CoreLink™
DMA Controller (DMA-330)
Errata Notice

This document contains all errata known at the date of issue in releases up to and including revision r0p0 of PL330 AXI DMA Controller and revision r1p1 of DMA-330 CoreLink DMA Controller.

720043: DII 0193A DMAC (PL330) r0p0 IM - Clock enable functionality in pl330_pl080_interface is not documented

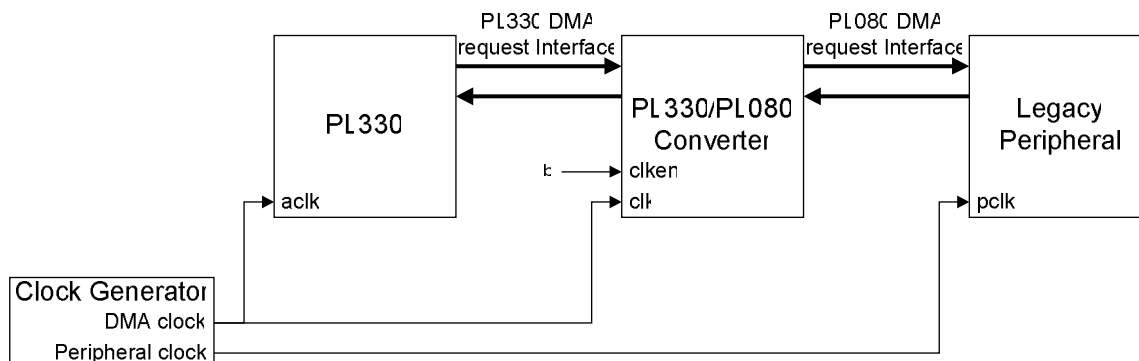
Appendix A of the PL330 Integration Manual describes the DMA Request Interface Converter, which allows you to connect a legacy peripheral that implements a PL080-style DMA request interface to PL330. Figure A-1 "Converter connections" on p.A-2 illustrates the integration of the converter block into a system but does not include the clken input port of the converter.
